Preservation Department – Item 1, LPC-22-08731

**6301 12th Avenue, aka 6301-6323 12th Avenue, 1202-1216 63rd
Street, and 1201-1215 64th Street – Angel Guardian Home –
Individual Landmark
Borough of Brooklyn**

LPC-22-08731: 6301 12th Avenue, Angel Guardian Home - Individual Landmark

PUBLIC MEETING SCOPE 09/20/2022

REVISED DESIGN:

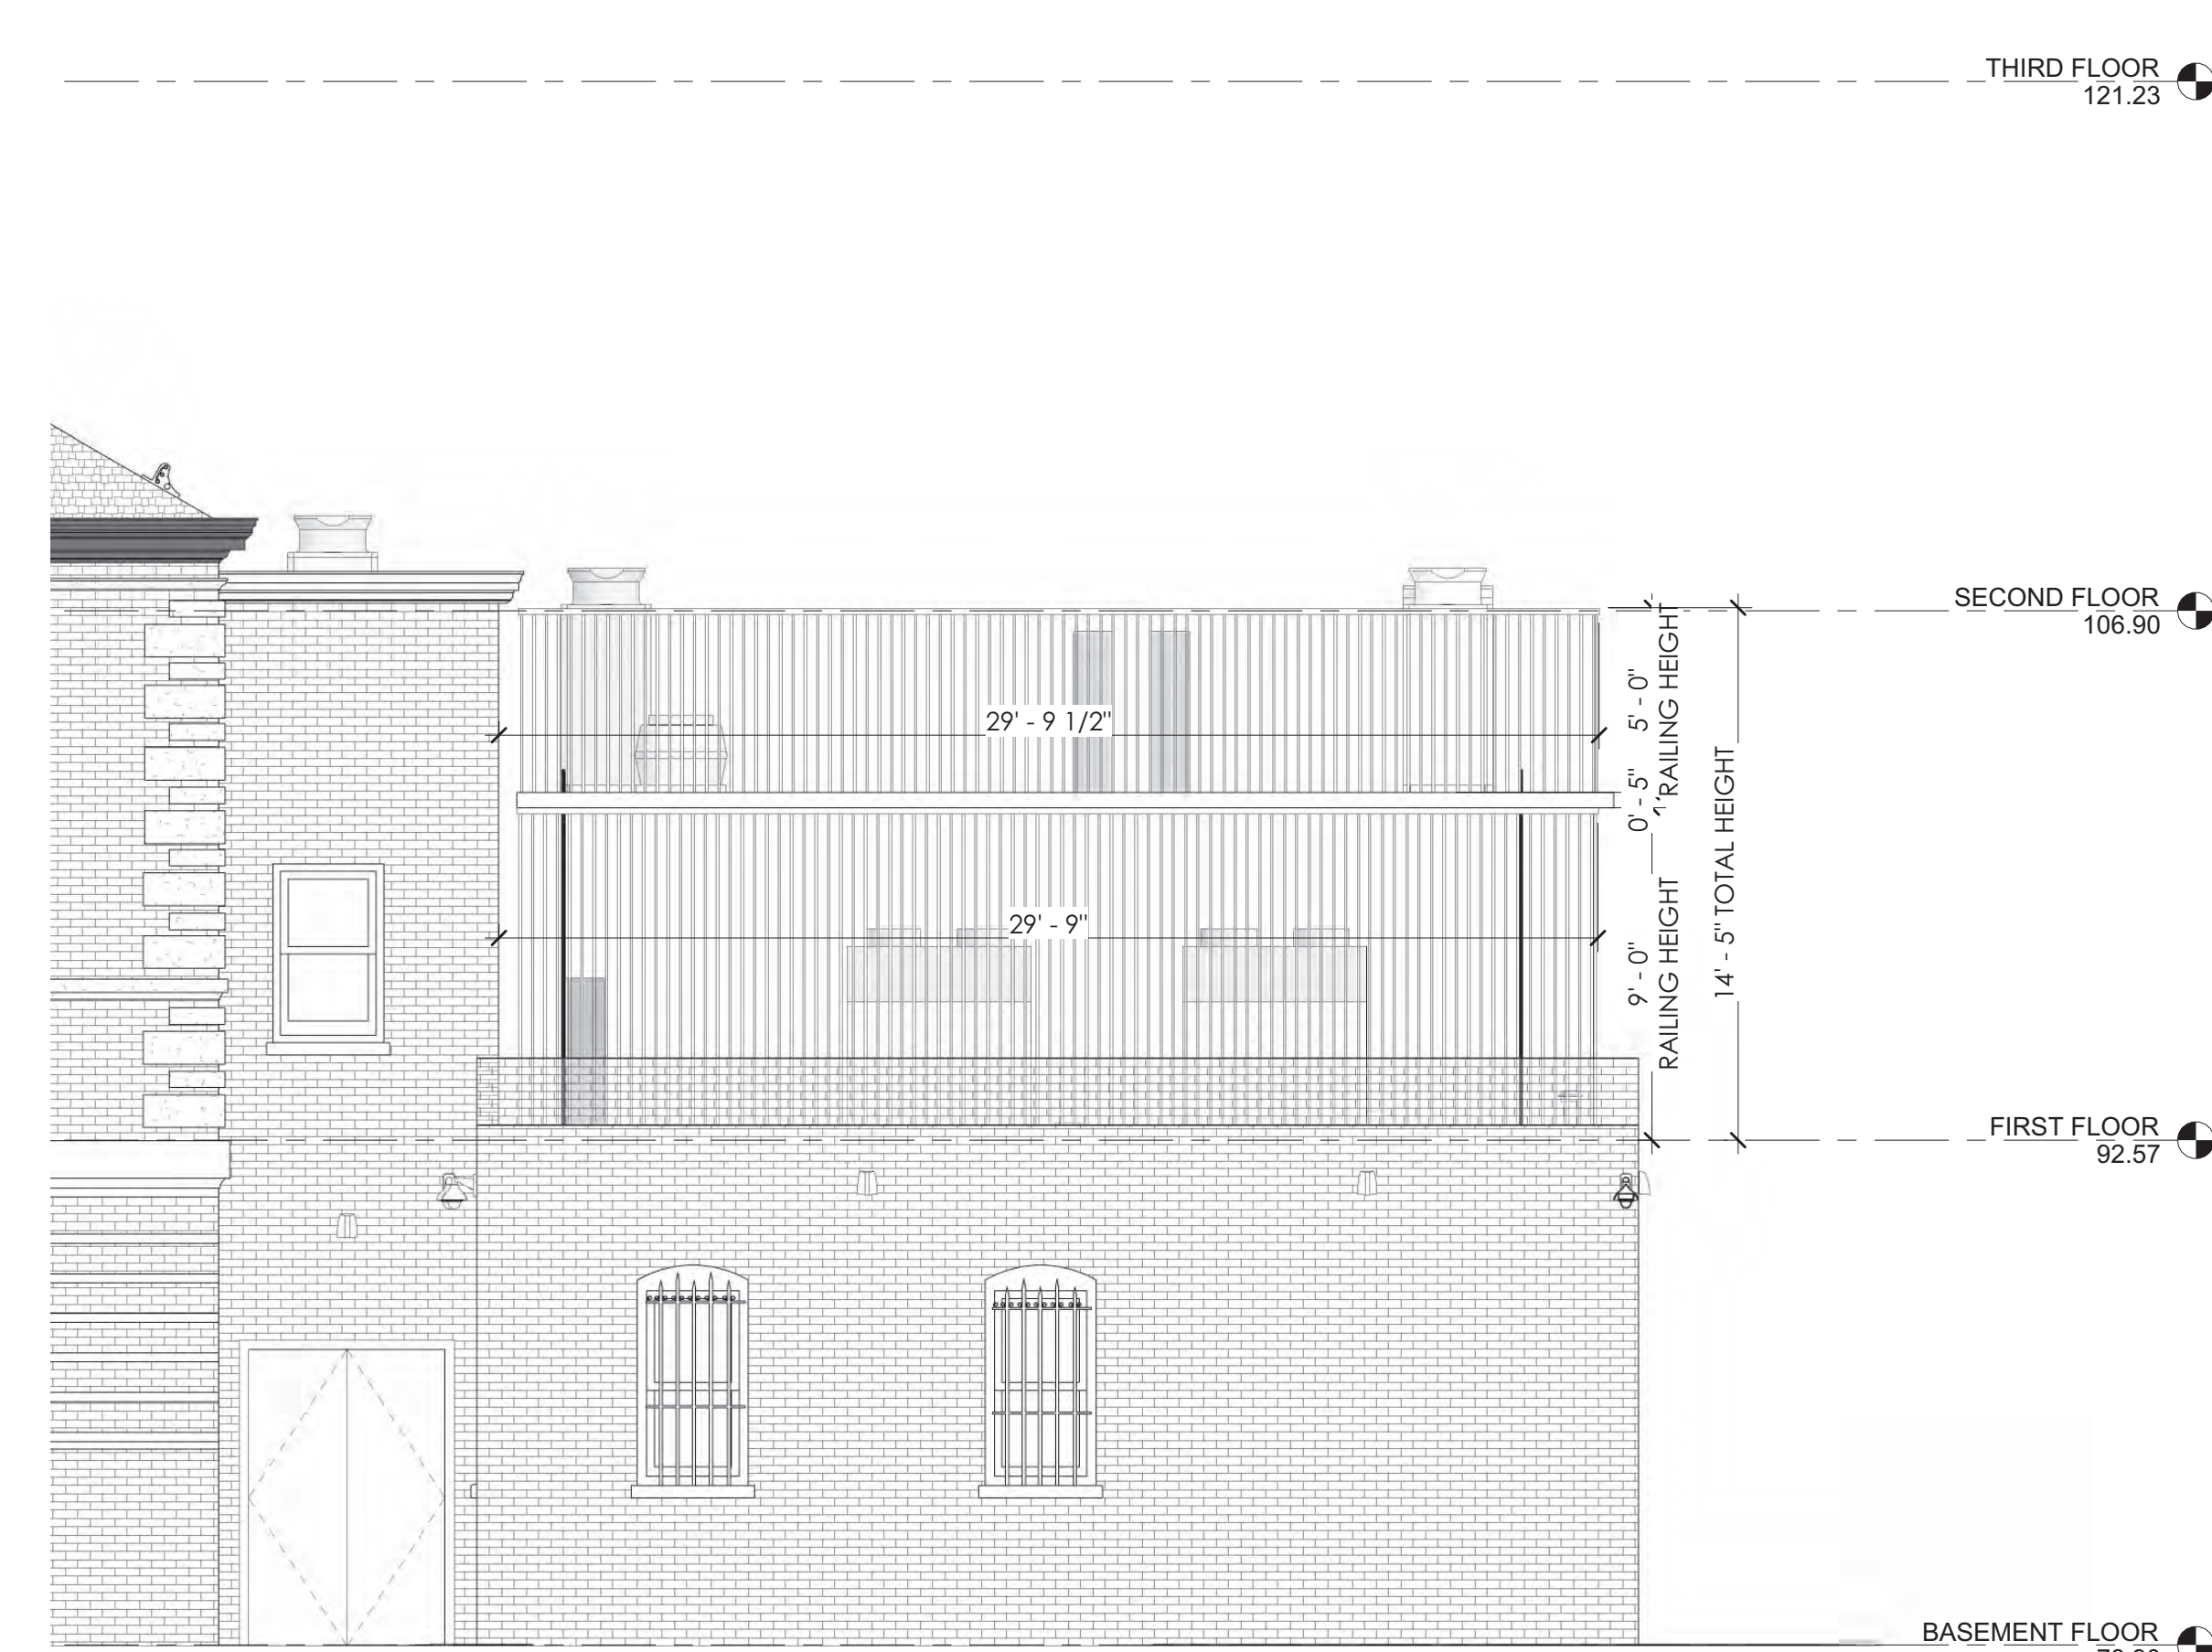
- CHANGES:**
- RAISED HEIGHT OF FIRST LEVEL DUNNAGE
 - REMOVED SECOND LEVEL DUNNAGE SETBACK
 - WIDE MECHANICAL LOUVRE REMOVED
